## RECALL CAMPAIGN 16V-746: REPLACE LOW-PRESSURE ELECTRIC IN-TANK FUEL PUMP

### What's New:

- **New part inspection before installation.**

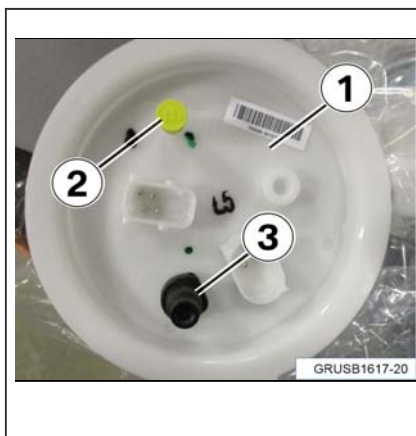
2. Inspect the new fuel pump assembly white plastic lid (1).

The yellow transportation cap for the fuel supply line (2) must be removed and discarded before installation. The black plastic cap (3) must not be removed. If removed, a fuel leak may develop if an open port is present. If the new fuel pump is received without this the black plastic cap (3) and an open port is present then another fuel pump must be ordered.  
**Do not use a fuel pump that is missing the black plastic cap (3) and it has an open port which may cause a fuel leak.**
